PROJECT: POUND PLACE
ROUNDSTONE ROAD
ANGMERING

DRAWING TITLE: PROPOSED DRAINAGE LAYOUT
64 BED
SHEET 3

JOB NUMBER:	SCALE AT A1:	REV. STATUS:
SE1612	1:100	S4
DRAWING NUMBER:		REVISION:
PP-ISS-XX-XX-DR-C-3013		C07

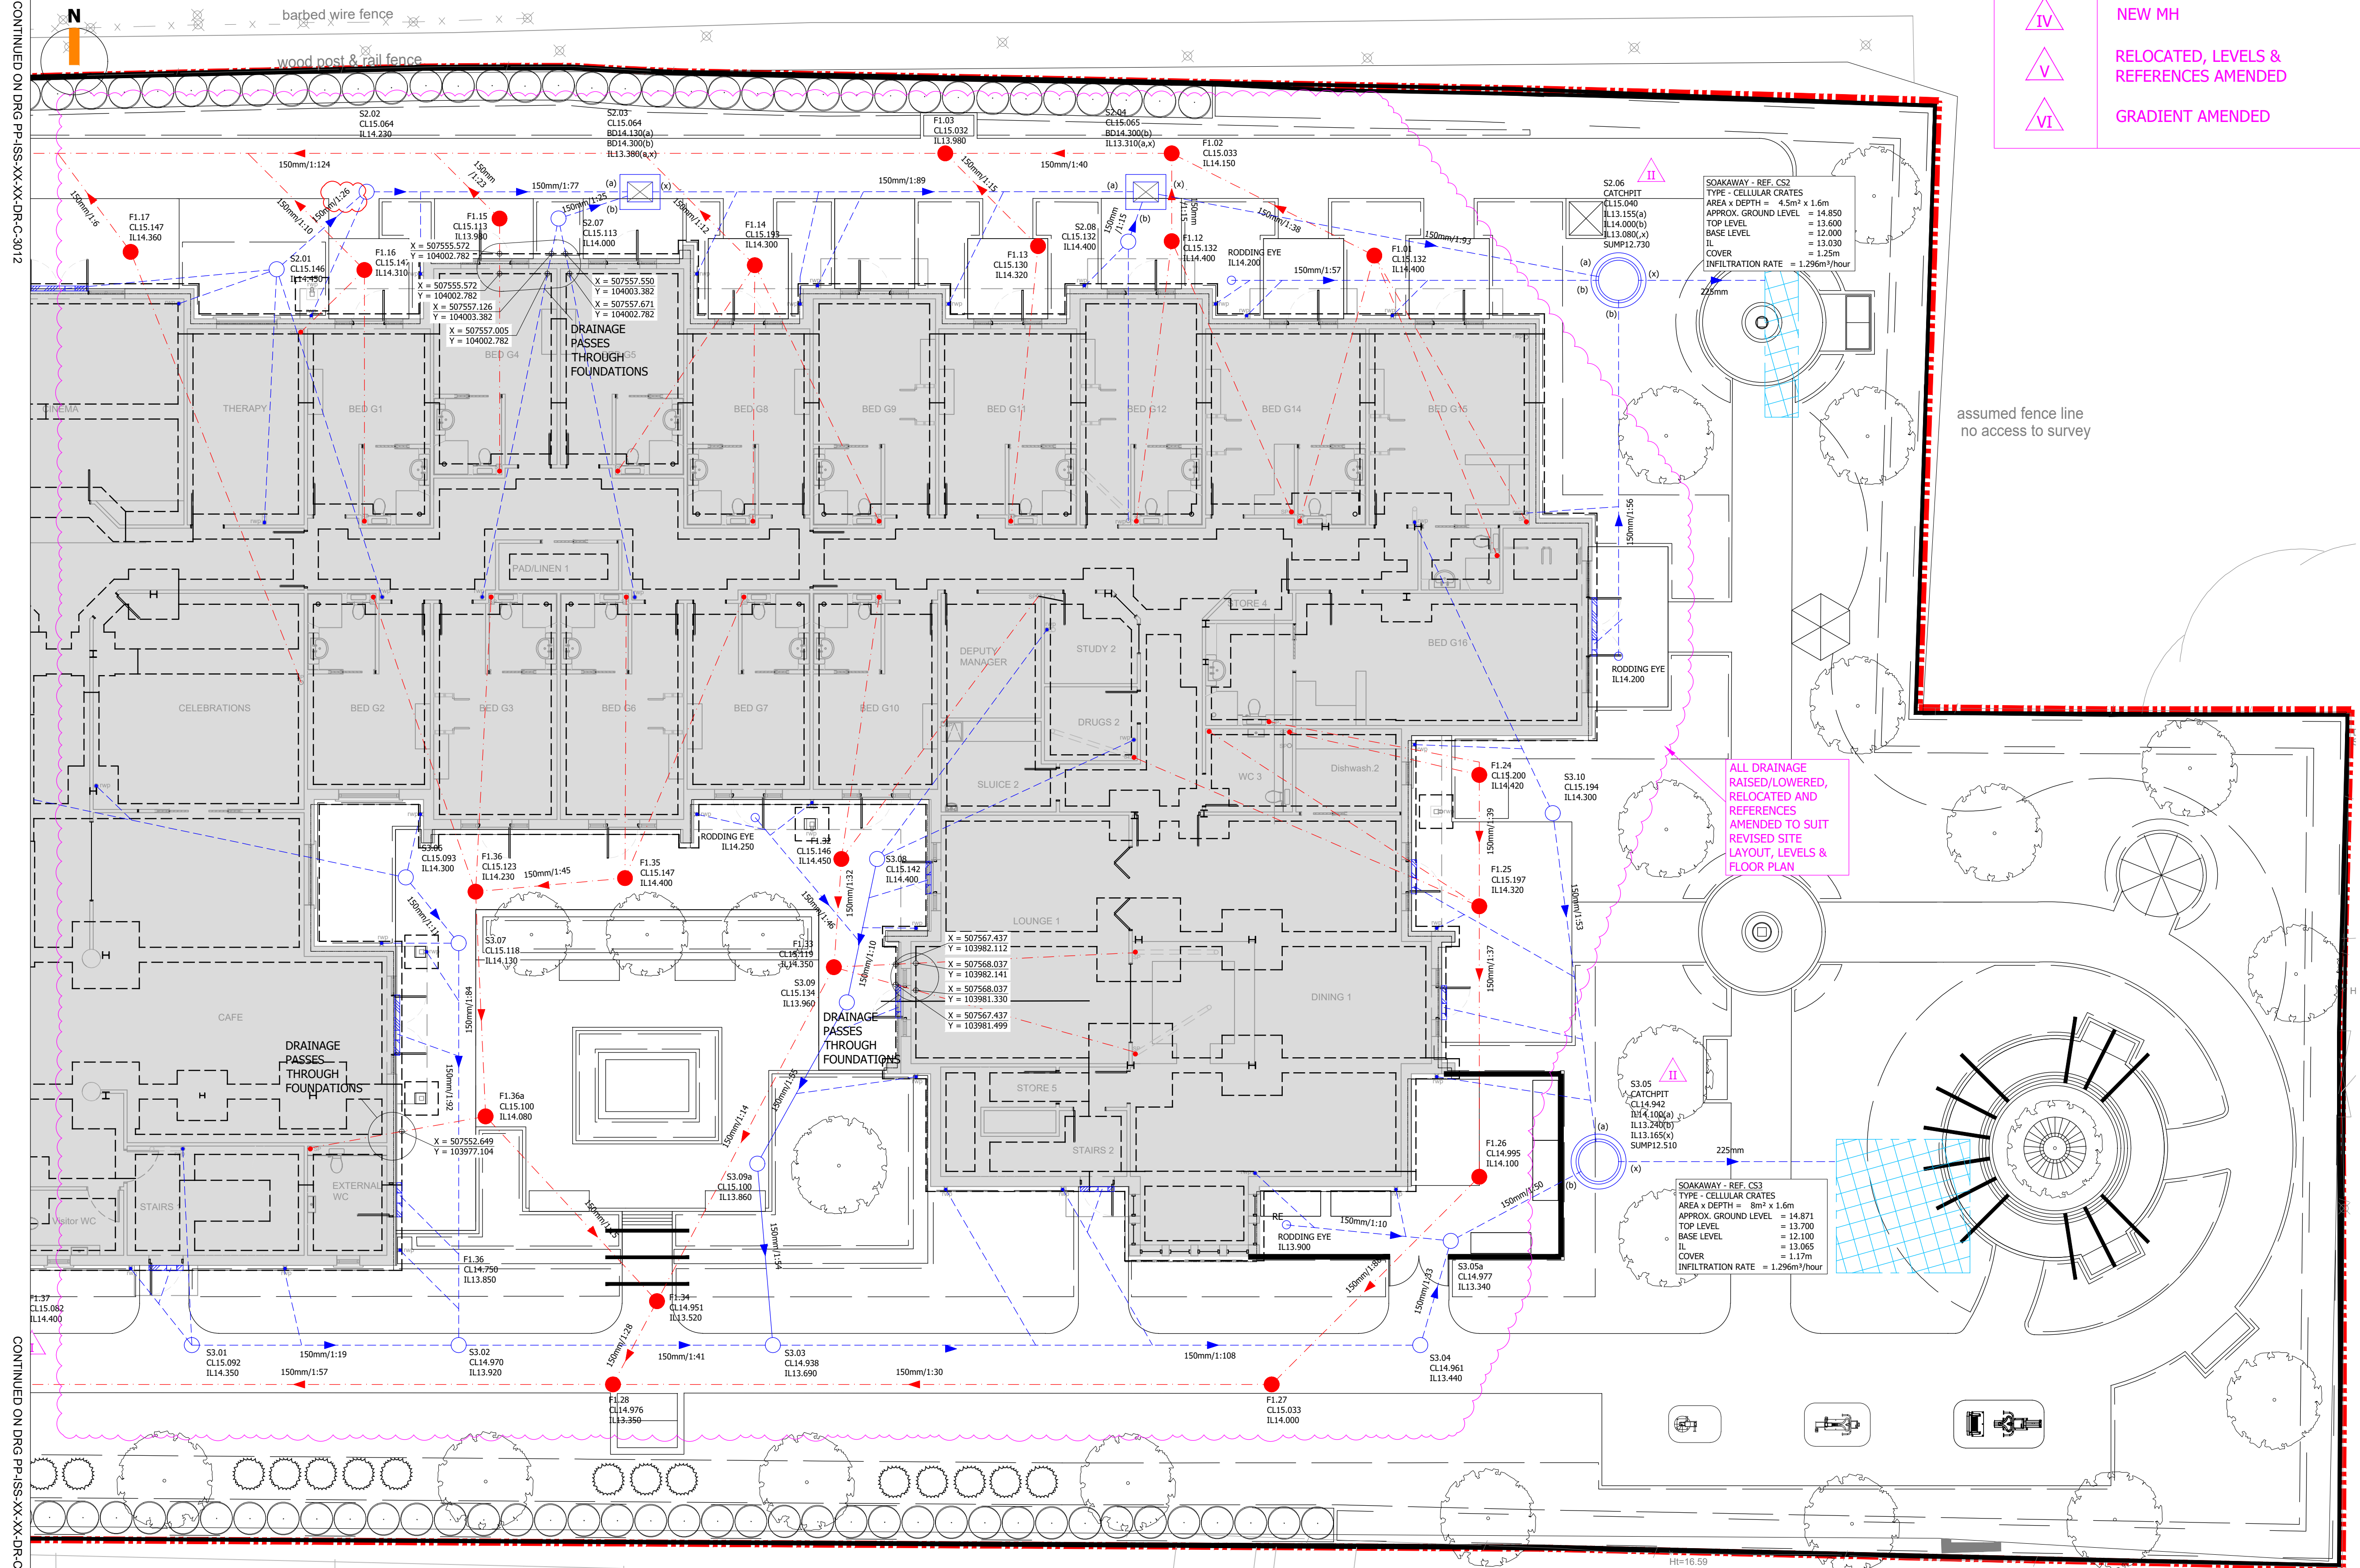
DESIGN CHANGES FROM 62 BED SCHEME TO 64 BED SCHEME	
REFERENCE	CHANGES
I	REFERENCE, COVER + INVERT LEVELS AMENDED
II	COVER + INVERT LEVELS AMENDED
III	RELOCATED (LEVELS AMENDED)
IV	NEW MH
V	RELOCATED, LEVELS & REFERENCES AMENDED
VI	GRADIENT AMENDED

ALL DRAINAGE RAISED/LOWERED, RELOCATED AND REFERENCES AMENDED TO SUIT REVISED SITE LAYOUT, LEVELS & FLOOR PLAN
